## ADDENDUM No. 4

### Municipality of Huron Shores Potomac Bridge Replacement TULLOCH Project 22-0887

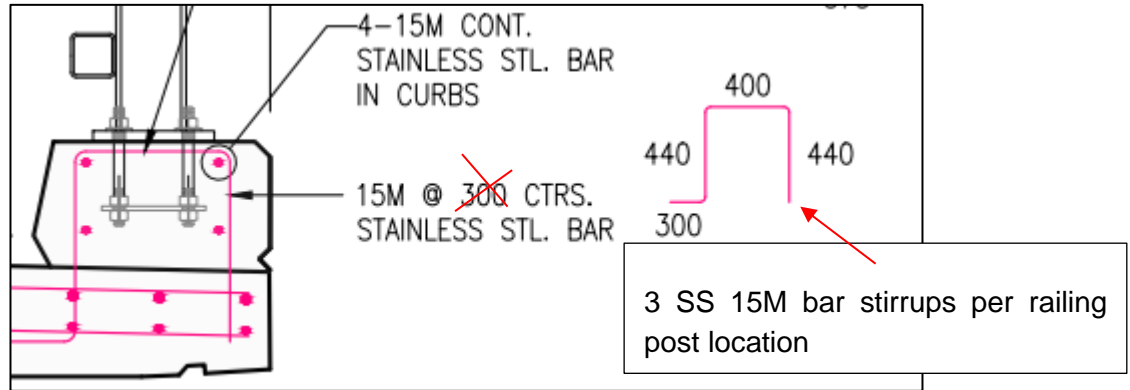
1. Item B9 H-Pile Load Testing - Please clarify the number of piles to be load tested? Are both abutments considered 1 group for the purposes of pile load testing or are they to be considered separate groups?

Each abutment shall be considered its own “group” for the purposes of establishing the number of pile tests. The first pile installed on each abutment would be pile load tested (PDA testing) to ensure that the set criteria for the required resistance can be established for the remaining piles. Per the OPSS 903, upon completion of the installation of the abutment piles, 2 piles at random will be “re-tapped” in the group to confirm the ultimate resistance.
